DESIGN PH	DRAWN BY PH	DART AEROSPACE USA, INC. PORT HADLOCK, WA	
CHECKED [Signature]	APPROVED [Signature]	DRAWING NO. DSI 9343	REV. A SHEET 1 OF 1
DATE 06.07.12		TITLE D350-636-011/-012 SPACER	SCALE NTS
A	06.07.12	NEW ISSUE

DART SERVICE INSTRUCTION

TO AMEND DRAWING IIN-D350-636 REV. D

SECTION A-A: DART D350-636-011/-012 SKIDTUBE
(LH SHOWN, RH OPPOSITE)

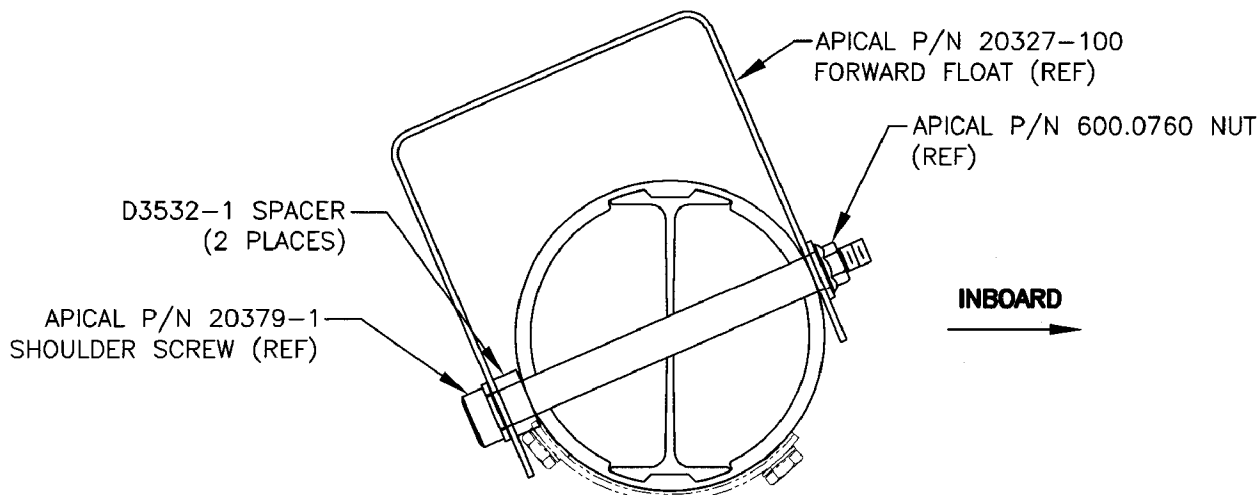
WHEN INSTALLING THE APICAL P/N 20327-100 FWD FLOATS ONTO THE DART D350-636-011/-012 SKIDTUBES, INSTALL THE DART D3532-1 SPACER AS SHOWN IN SECTION A-A TO ALLOW CLEARANCE FROM THE FWD WEARPLATES.

ADD THE FOLLOWING PARTS TO THE PARTS LIST ON PAGE 10 AND 11 OF IIN-D350-636 REV D:
